# Technical Service Bulletin

**NUMBER:** 19-02-00 Rev. A

**GROUP:** Steering

Ignition Lock Cylinder Service

**FIGURE 1**

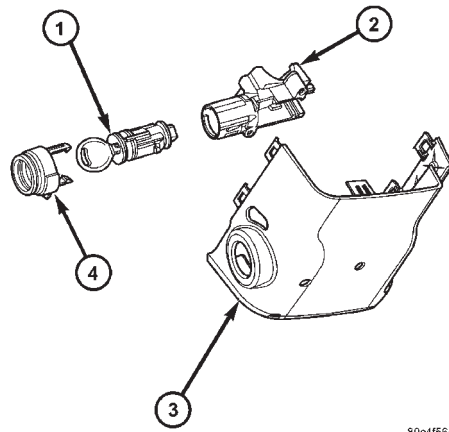
Recent changes to the ignition lock cylinder have resulted in the removal of a chamfer on the lock cylinder retaining pin. This may cause the pin to hang up on the plastic trim ring when the lock cylinder is removed. If this situation is encountered on any of the models listed above, it may be necessary to remove the trim ring prior to removing the lock cylinder. This is done by unseating the retaining tabs on the trim ring and removing it. The lock cylinder can then be removed without any interference (See Figure 1). Future models will modify the lock housing to eliminate this condition.
